PROJECT *(Name and Address)*
EAST HEIGHTS ELEMENTARY SCHOOL RENOVATION
1776 ADAMS LANE
HENDERSON, KY 42420

CHANGE ORDER NUMBER: 5-2
INITIATION DATE: 6/11/2025

PROJECT NUMBERS: 000847
CONTRACT DATE: 1/6/2025
CONTRACT FOR: BID PACKAGE #05 GYPSUM ASSEMBLIES

Henderson County East Heights Elementary Renovation
PR #05 05/28/2025

5 PHASE 2 - ENLARGED MEDIA CENTER RCP
1/4" = 1'-0"

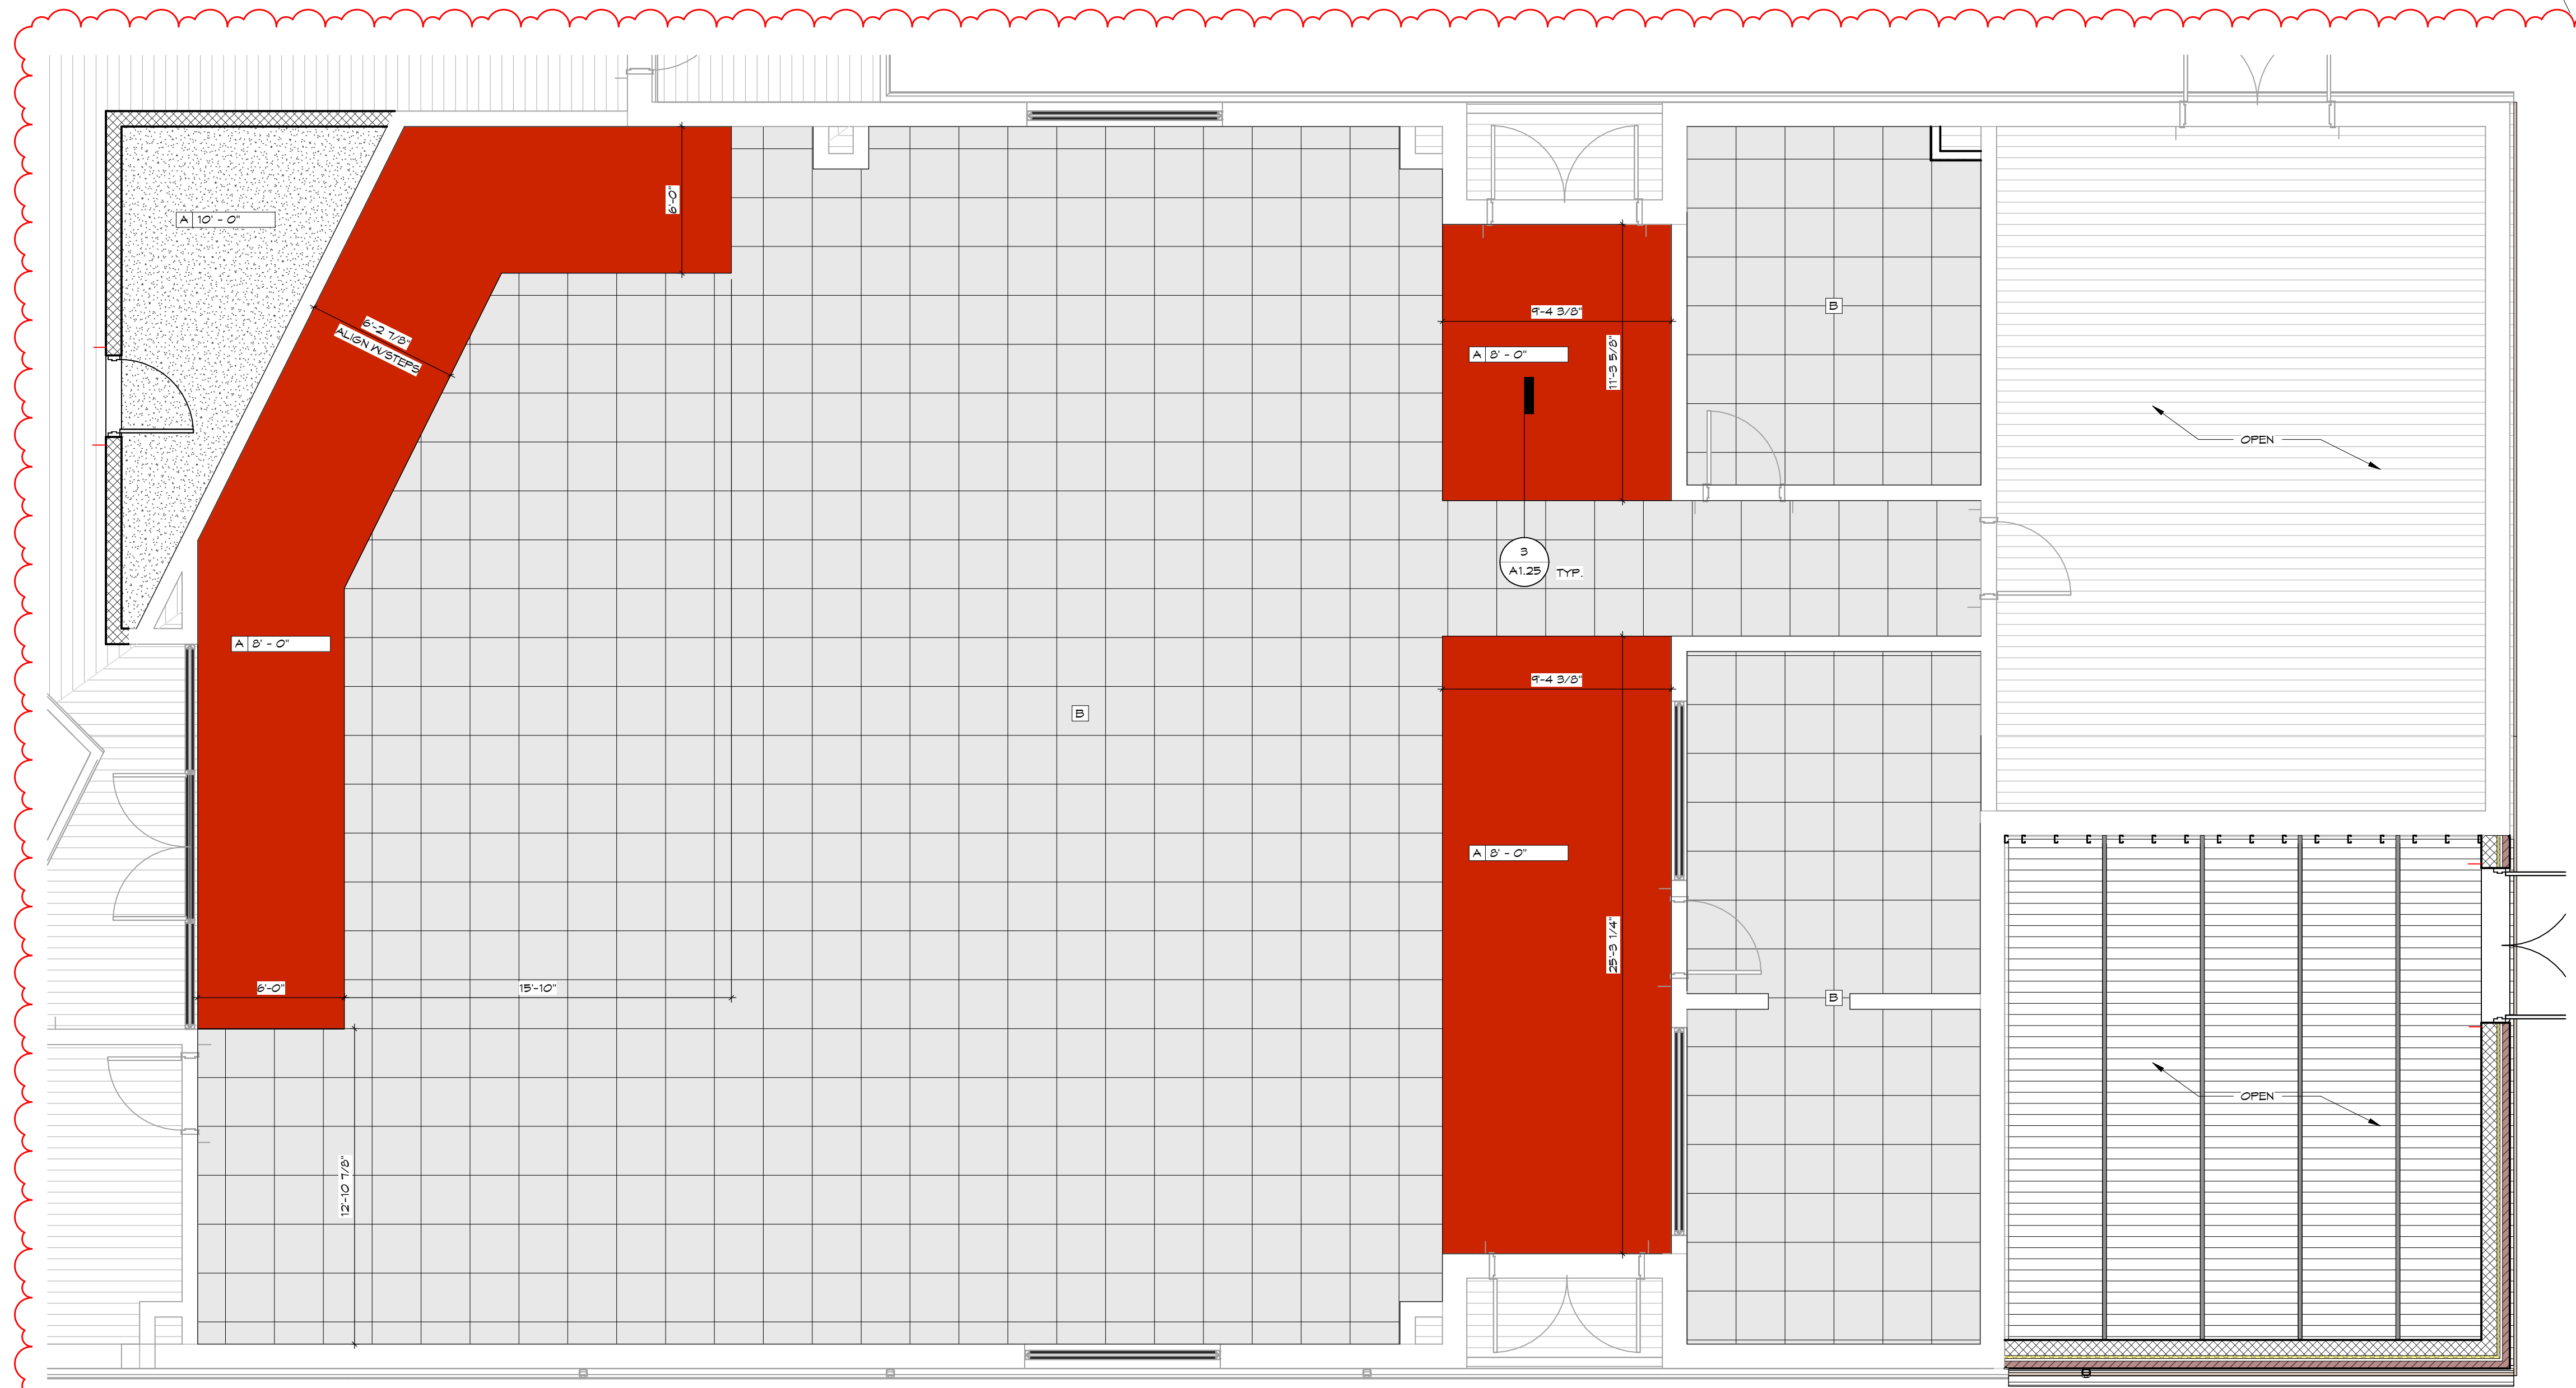
Please provide a credit, including materials, labor and fees for the simplification of the ceiling design in the Media Center.

Refer to attached A1.25 for new ceiling design.

- Revise drywall ceilings and bulkheads and acoustical ceilings in the Media Center as shown on revised drawing sheet A1.25

Item #1 Refer to Sheet M2.23 – Air Distribution New Work Plan – Phase 2 – Area D

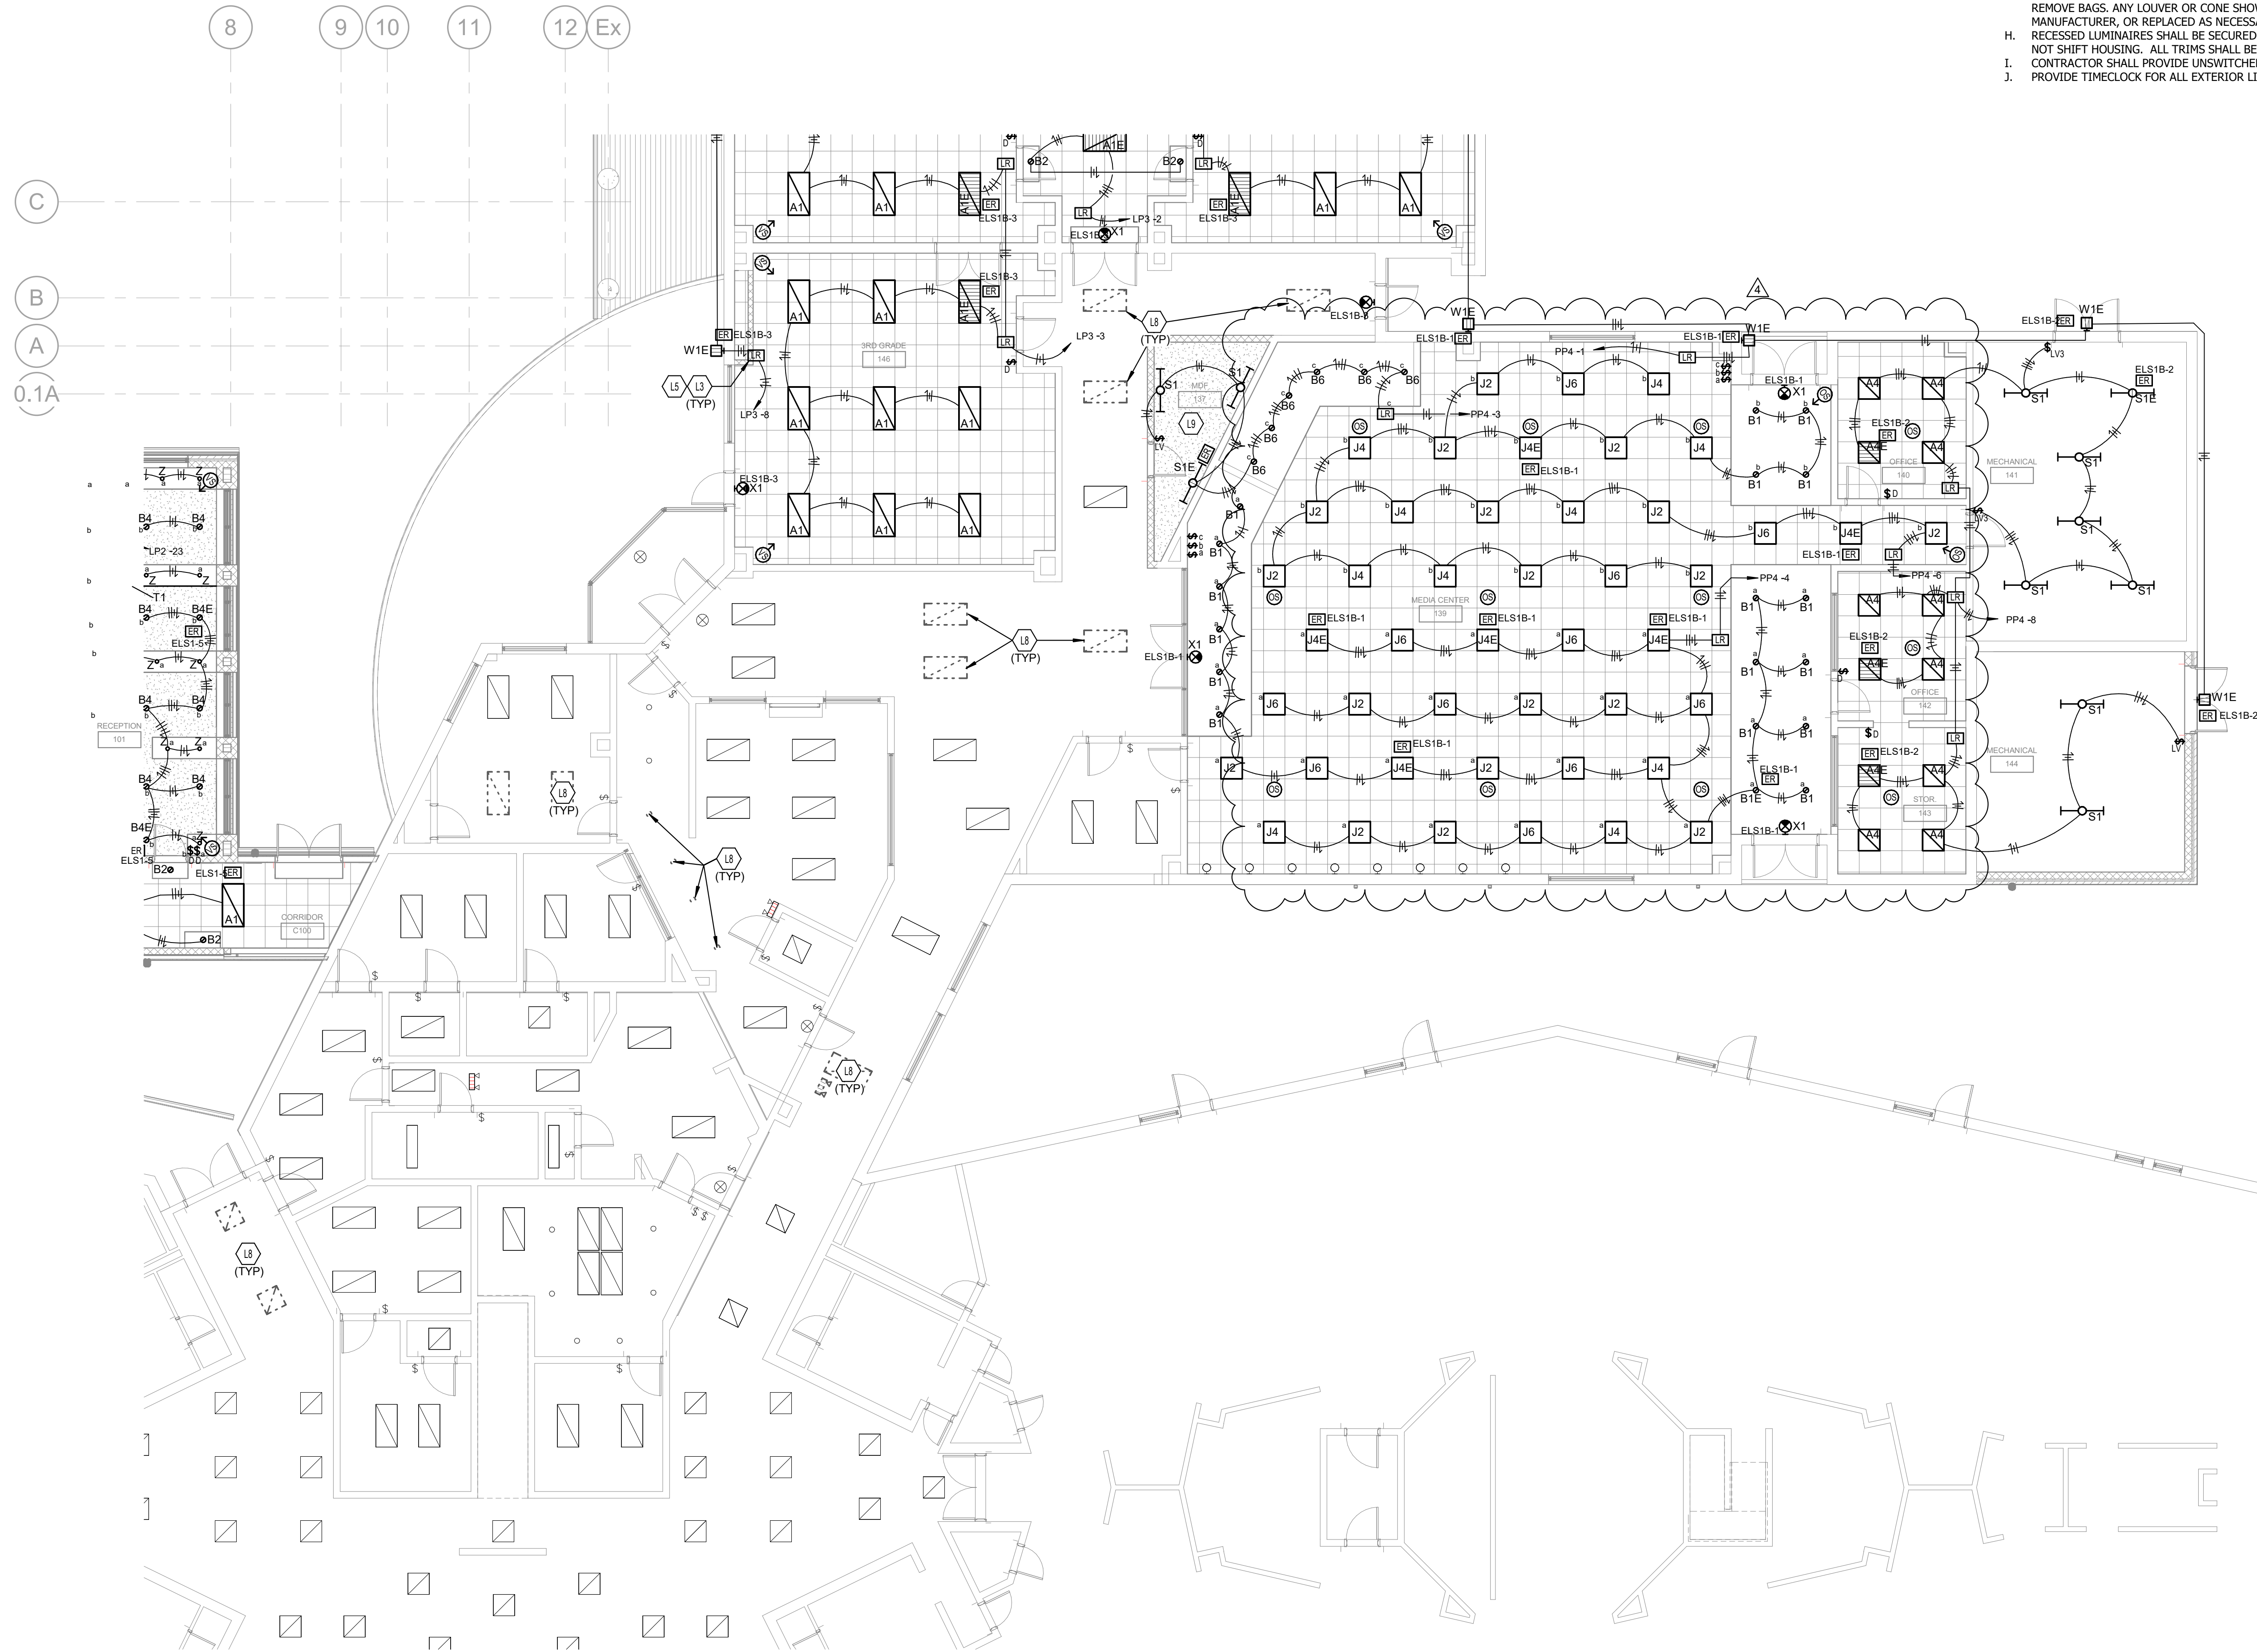
Refer to attached M2.23 for new diffuser layout.

A. Modified diffuser layout accommodate ceiling change.

Refer to attached E2.23 for new light fixture layout. 6 Type B1 fixtures have been added; refer to home run pane-circuit number and update panel schedules as required.

Item #2 Refer to Sheet E2.23 – New Work Lighting Plan – Phase 2 – Area D

A. There were a total of six (6) Type B1 fixtures newly added to the Media Center space. Refer to home run pane-circuit number and update panel schedules as required.
